PROPOSED CHANGE OF USE OF
 AGRICULTURAL LAND TO PADDOCK
 TO ERECTION OF STABLE BLOCK
 AND ASSOCIATED FENCING &
 MANURE STORAGE.

BLOCK PLAN
 SCALE 1/500
 DRWG No 042
 SKETCH Lot 2.

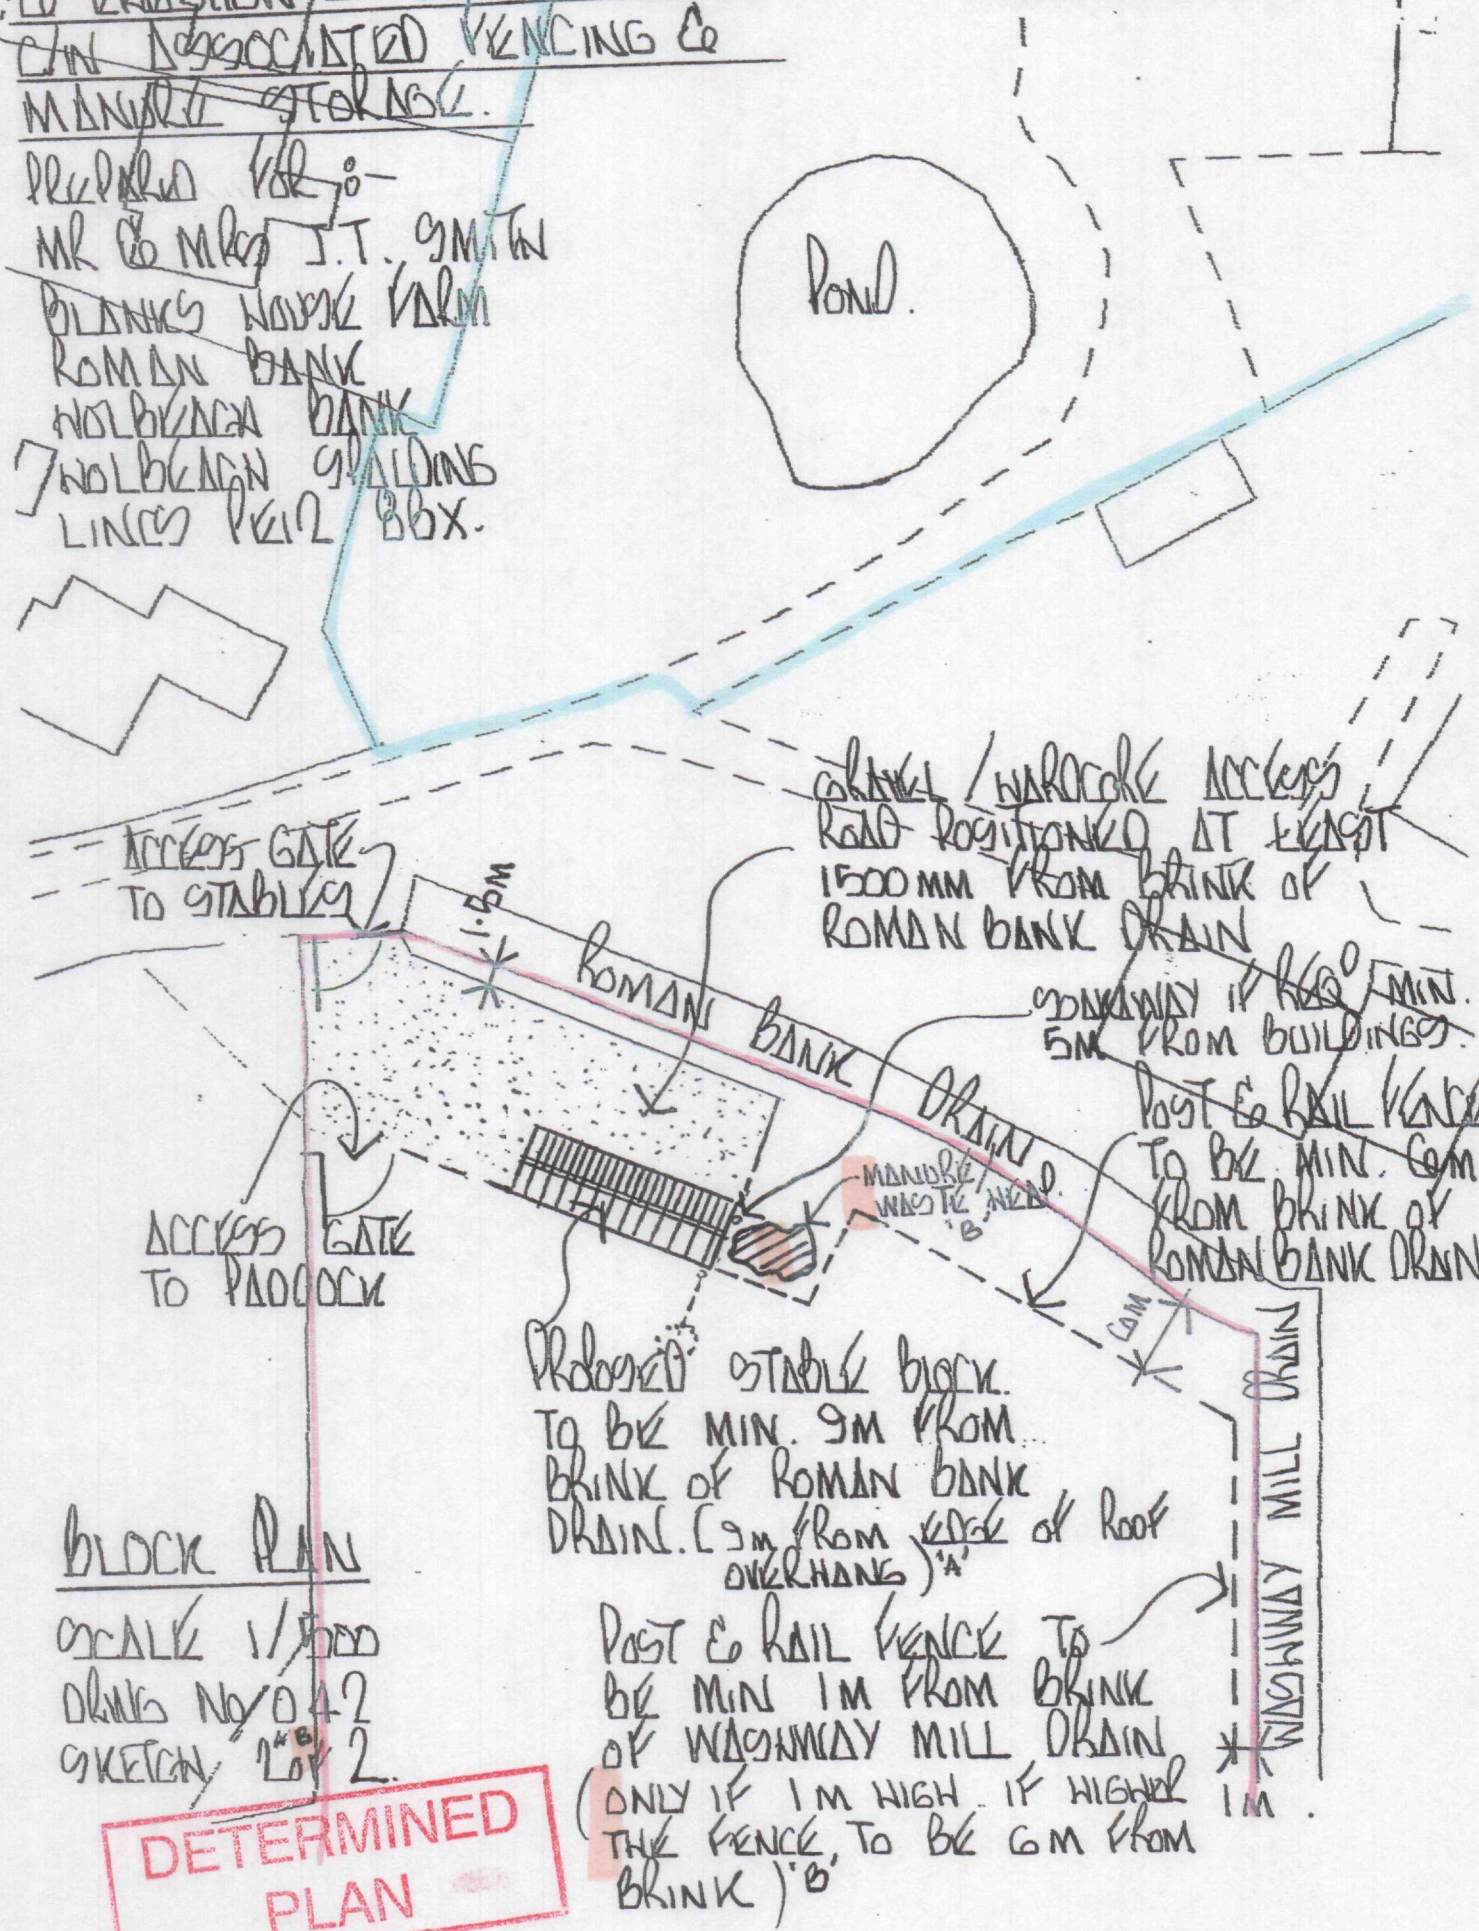
REV 'A' EDGE OF ROOF OVERHANGS TO
 STABLE NOTE ADDED 25/4/03.
 REV 'B' HT OF FENCE ADDED TO
 WASHWAY MILL DRAIN.
 MANURE HEAP ADDED 28/5/03.

PROPOSED STABLE BLOCK
 TO BE MIN. 9M FROM
 BRINK OF ROMAN BANK
 DRAIN. (9m from edge of roof
 OVERHANG) 'A'
 POST & RAIL FENCE TO
 BE MIN 1M FROM BRINK
 OF WASHWAY MILL DRAIN
 (ONLY IF 1M HIGH. IF HIGHER
 THE FENCE, TO BE 6M FROM
 BRINK) 'B'

SHED / WAREHOUSE ACCESS
 ROAD POSITIONED AT LEAST
 1500MM FROM BRINK OF
 ROMAN BANK DRAIN
 WASHWAY IF REQ'D MIN.
 5M FROM BUILDINGS.
 POST & RAIL FENCE
 TO BE MIN. 6M
 FROM BRINK OF
 ROMAN BANK DRAIN
